REMARKS

Substitute drawing sheets 1 and 3 are submitted herewith. Figs. 2 and 9 have been amended. Specifically, in Fig. 9, reference numeral 16 and the lead line extending therefrom have been deleted due to the removal of layer 16 and going from Fig. 8 to Fig. 9. Such is clearly supported in Applicant's application as-filed at, for example the last two paragraphs on page 4, and on page 9, lines 3-6.

ANNOTATED SHEET SHOWING CHANGES

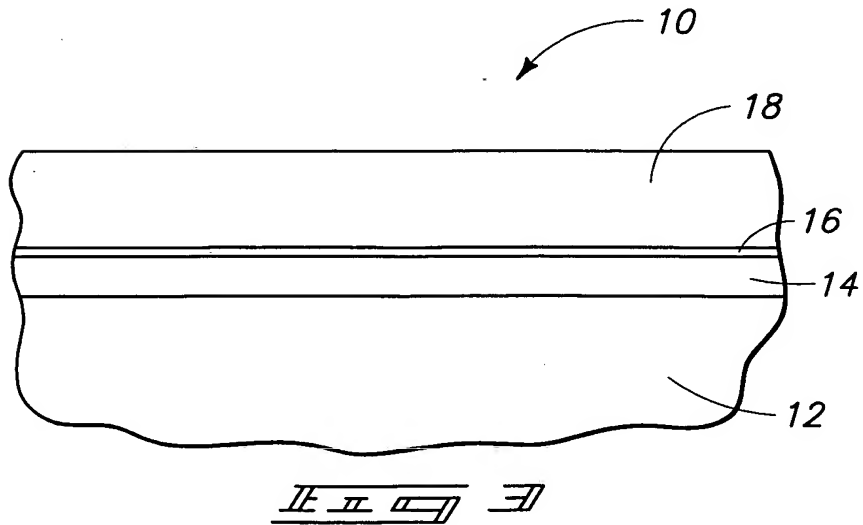
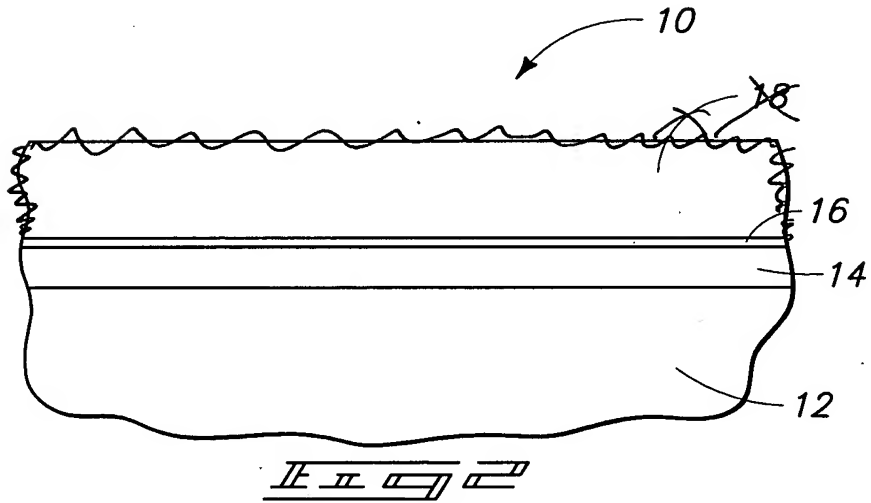
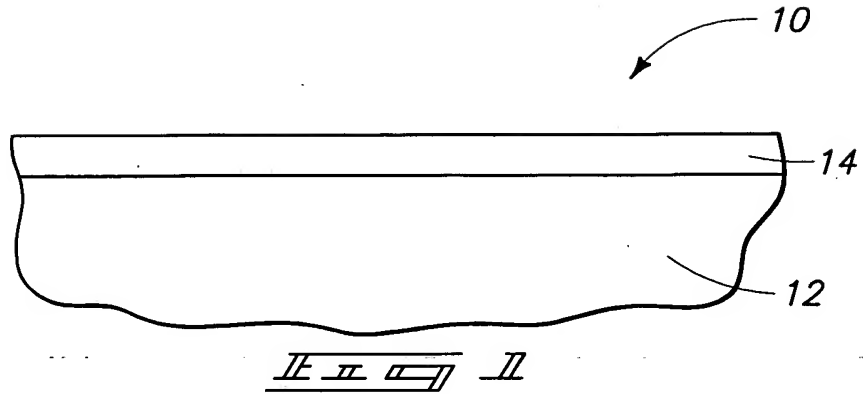
Regarding Figure 2, it was noticed in reviewing the application in preparation of this response that Figures 2 and 3 as presented in the application as-filed are identical. It is clear from Applicant's application as-filed that Fig. 3 follows processing or is subsequent to the processing of Fig. 2 and that material 18 was intended to be shown as coming into existence in Fig. 3, not in Fig. 2. See, for example, Applicant's application as-filed at p.4, Ins.8, 9, and p.5, ln.18 - p.6, ln.18. Clearly, there is no reference to photoresist layer 18 in Fig. 2, with such only being introduced with respect to Fig. 3 processing. Accordingly, no new matter is added by fixing this minor oversight in Fig. 2. It is respectfully requested that the drawings as amended herein be entered.
